Third amendment of the Day-Ahead Capacity Calculation Methodology of the Core Capacity Calculation Region

in accordance with Articles 20ff. of the Commission Regulation (EU)
2015/1222 of 24th July 2015 establishing a guideline on capacity allocation
and congestion management

8th December 2023

Figure 1: Determination of external constraints in export direction (generating capacities available for potential exports) in the framework of the day-ahead capacity calculation.

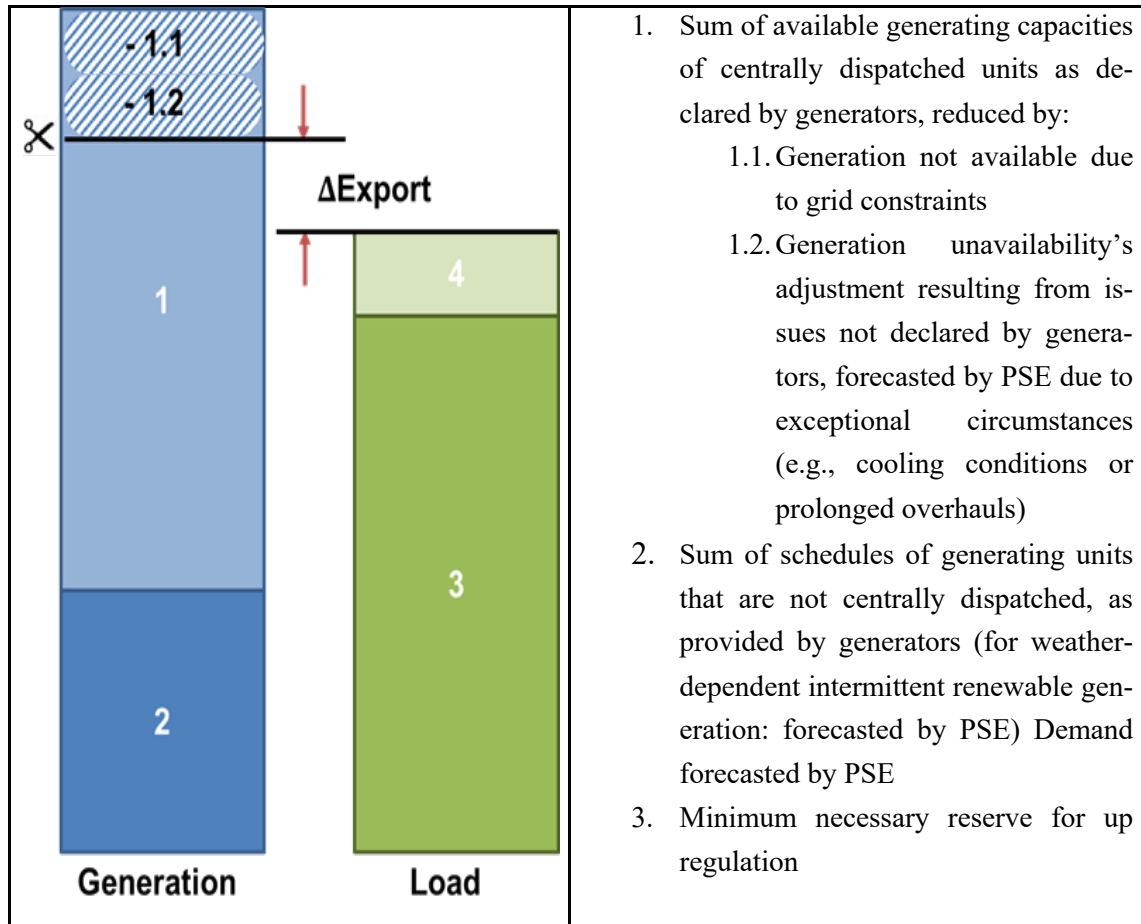
For illustrative purposes, the process of practical determination of external constraints in the framework of the day-ahead capacity calculation is illustrated below in Figures 1 and 2. The figures illustrate how a forecast of the Polish power balance for each hour of the delivery day is developed by PSE in the morning of D-1 in order to determine reserves in generating capacities available for potential exports and imports, respectively, for the day-ahead market.

External constraint in export direction is applicable if D_{Export} is lower than the sum of cross-zonal capacities on all Polish interconnections in export direction. External constraint in import direction is applicable if D_{Import} is lower than the sum of cross-zonal capacities on all Polish interconnections in import direction.
